SUBJECT: Chain Oiler, Model 17 & 5-20 Saws

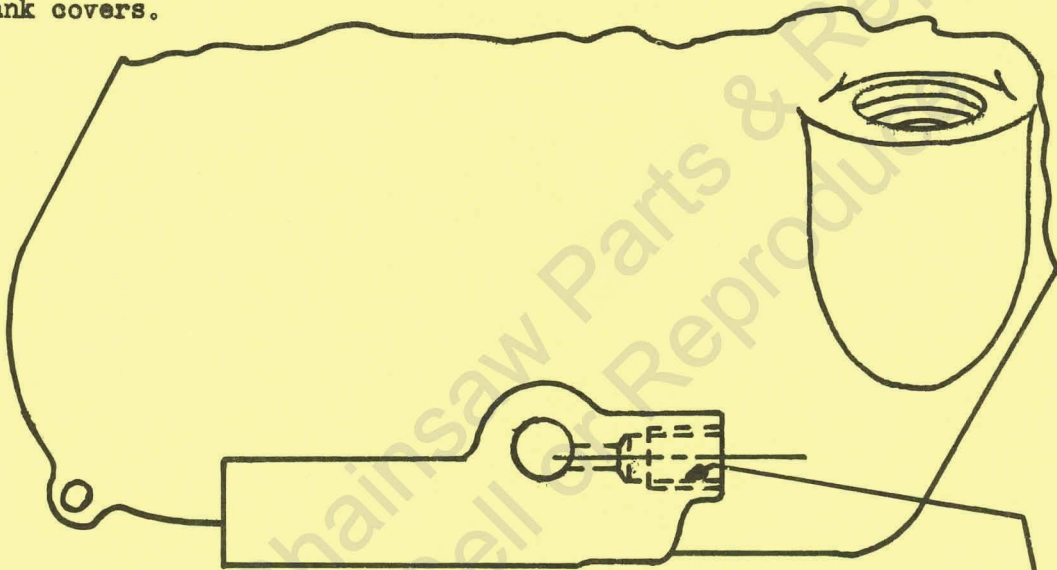
A self-contained outlet check valve, Part No. A-55824, replaces the Ball, Spring and Adapter in the oil outlet of Model 17 and 5-20 fuel tank covers.

CHECK VALVE FITS HERE
 NEW THREAD 5/16-24
 OLD THREAD 1/4-28

The new check valve can be used in old fuel tanks, provided the cover is retapped 5/16-24. All replacement fuel tanks will contain the 5/16-24 hole and must use A-55824 check valve.

SUBJECT: Bow Attachment for Model 17 and 5-20 Saws

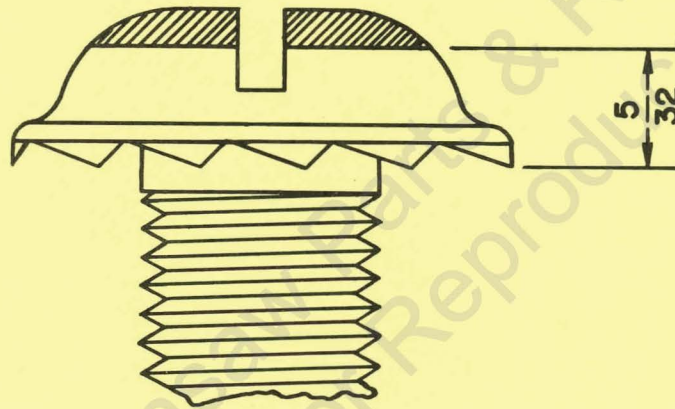
Starting immediately we will machine the heads of the pan head screws which fasten the Bow Guide to the bottom of the Bow Mounting Plate.

The shaded portion is removed from the head of the screw to prevent interference-so that the bow mounting plate will seat flat on the mounting pad.

If you have any bow saws where this screw head is too high, grind the head as shown in the sketch above.

We will supply machined screws under Part No. 80593-1.

SUBJECT: Fuel Cap Valve

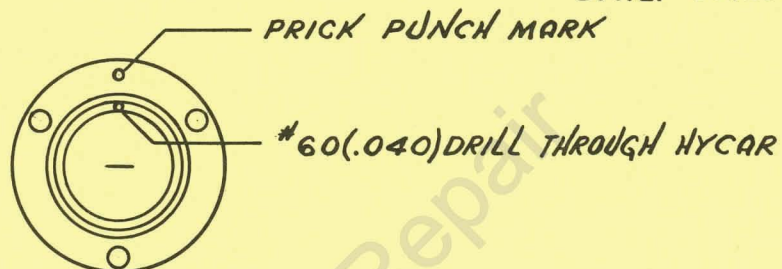
Some of the "Power Ingredients" which gasoline manufacturers have recently added to their fuels tend to swell Hycar.

For this reason we have discontinued the use of Hycar as a material for the Fuel Tank Cap Valve. Instead we now use Thiokol, a rubber like material which works well even with the latest gasolines.

To reestablish proper venting of the fuel tank, drill a #60 (.040") hole through the Hycar valve. The hole should be located in the circular depression, just opposite the prick punch mark on the aluminum retainer (see sketch above). The #60 drill will actually leave a hole smaller than .040" in the Hycar, but this small hole will work just right in the older valves.

SUBJECT: Remedy for Sticky Starter

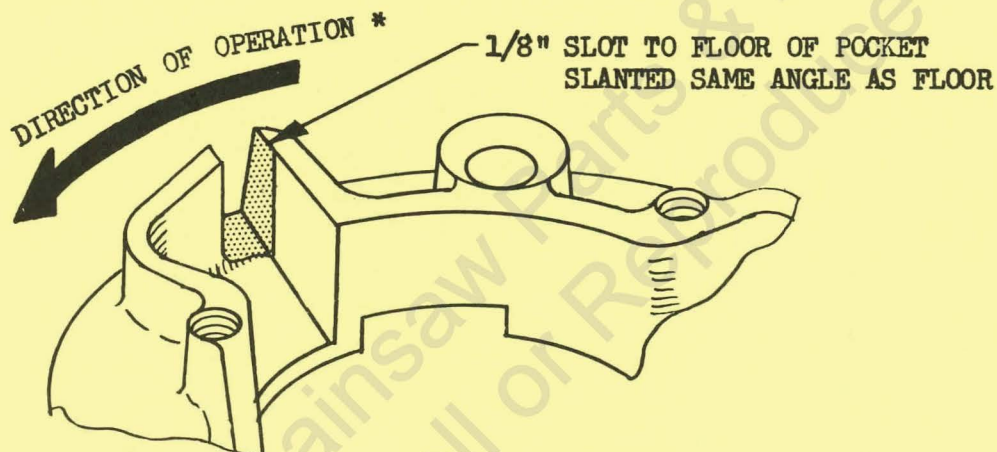
If you have customers who complain that the recoil starter mechanism on their saw doesn't engage every time, you can help them by modifying the Ball Drive Plate:

* Sketch shows slot for 26, 5-30, 7-29, and EZ
Slot for 5-20 and 17 located on opposite side.

If you file a 1/8" wide slot into each of the three Ball Pockets, as shown in the sketch, centrifugal force will tend to clean out the pockets while the saw is running. Make sure to locate the slot close to the trailing wall of the ball pocket and slant it so that it becomes a continuation of the pocket floor.
